MERCURY PERFORMANCE OUTBOARDS

service bulletin

No. 93-2

2.5 Exhaust Divider Plate Modification

40605

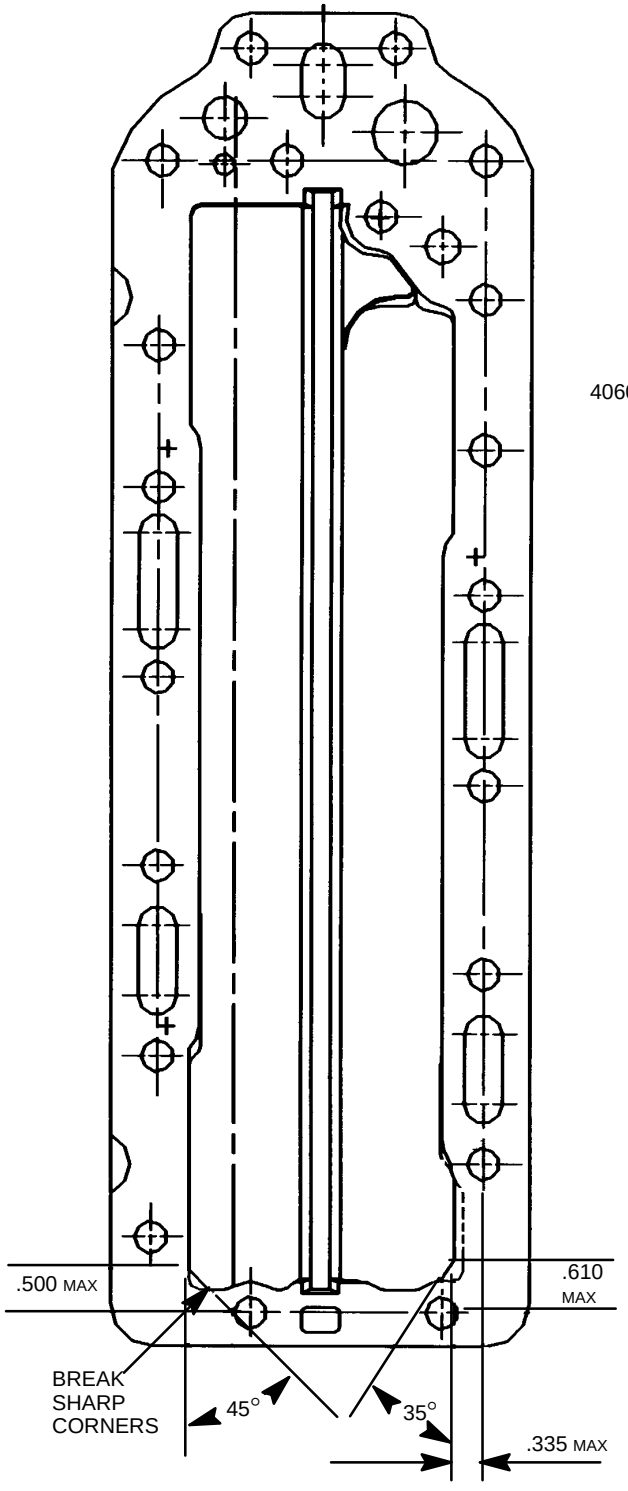
Cylinder block replacement of two bolt main 2.5 engines (S/N OD030202 thru OD030584 & OD110000 thru OD110711) may require either a new exhaust divider plate or a modification to the old plate. The new plate part number is 815552A-1. To modify the existing exhaust plate, file or machine the bottom corners as per illustration or until exhaust fits easily into the block.

a - Grind, File or Machine Material From These Areas
b - Break Sharp Corners In These Areas
